Planning, Land Use and Mobility Committee

Case Report

Lot Split and Flag Lot

Case Numbers: AA-2021-2130-PMLA
ZA-2021-2132-ZAA
ENV-2021-2131-CE

Preliminary Parcel Map for 23133 Oxnard Street

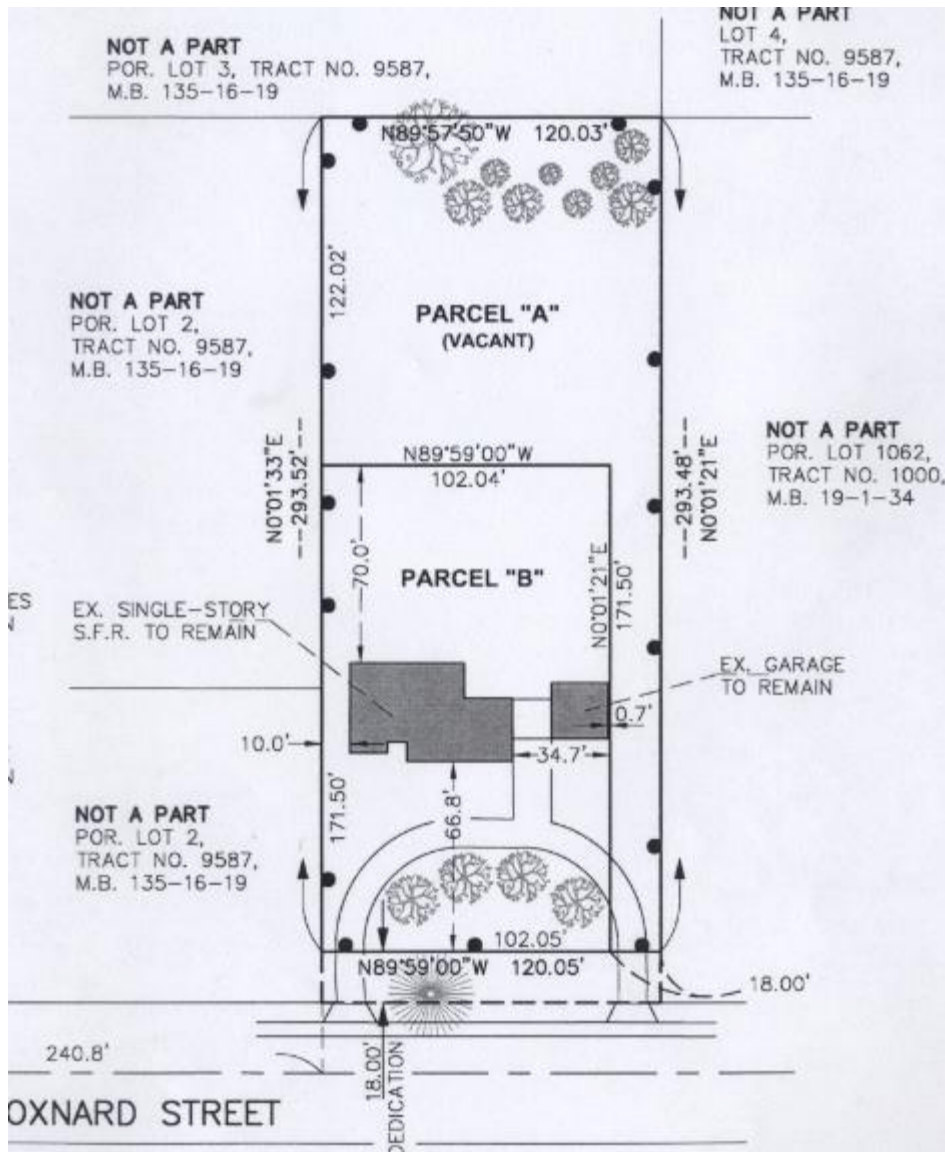
The applicant proposes to subdivide an approximately 37,384 sqft. RA-1 zoned lot into 2 lots creating a flag lot in the rear. The preliminary parcel map provided by the applicant shows the area of the front lot to be 17,500 square feet, and the area of the rear flag lot to be 17,731 sqft. when the subdivision is completed.

The lot split proposed by the applicant results in two lots each conforming to the LAMC minimum area requirement of 17,500 sqft. for RA-1 zoned lots. **However, the rear lot is 18 ft. wide at the midpoint and thus does not conform to the minimum lot width requirement of 70 feet at the midpoint as defined by LAMC Article 2, Section 12.07.C.4, and measured per LAMC Article 2, Section 12.03 stated below.**

WHEREAS, the Preliminary Parcel Map, provided by the applicant as part of the application, dated 3/16/21, shows 2 lots conforming to zoning regulations for square footage. However, the rear flag lot is 18 ft. wide at the midpoint and thus does not conform to the lot width requirement of minimum 70 feet at the midpoint for RA-1 zoned parcels as defined by Los Angeles Municipal Code (LAMC) Article 2, Sections 12.03 (lot width definition) and 12.07. C. 4, (“RA” Suburban Zone Standards minimum width requirement); and,
